INDIANA UNIVERSITY
CAPITAL PROJECTS

Addendum #2

Project: 20251391 - IN076 ICTC – IT 427 431 440C 557 Office Divisions

Date: June 23, 2026

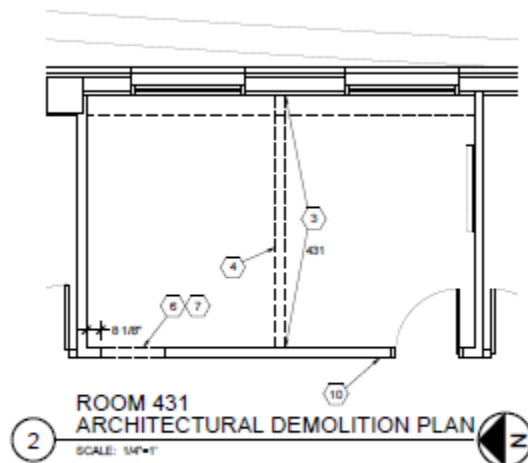
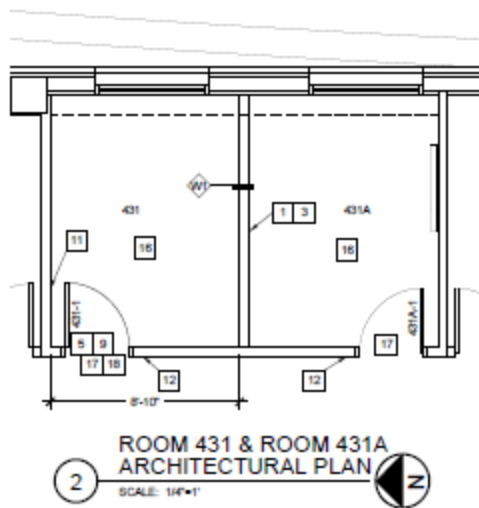
Q1. I would like clarification on a door discrepancy between the architectural drawings and the door schedule. On A201, in the Room 431/431A plan, it is indicated by notes 5 & 9 that door 431-1 is new. On the same drawing, it is indicated by lack of note 5 & 9 that door 431A-1 is not new. However, the door schedule lists 431A-1 for a new door and does not list 431-1.

Based on the demolition plan (A101), I assume that 431-1 is the only new door for room 431, and that in the door schedule “431A-1” should actually be listed as “431-1.” Please let me know if this is the correct assumption.

A1. Correct. Door 431A-1 is the existing door into the space and it will remain. Door 431-1 is a new door.
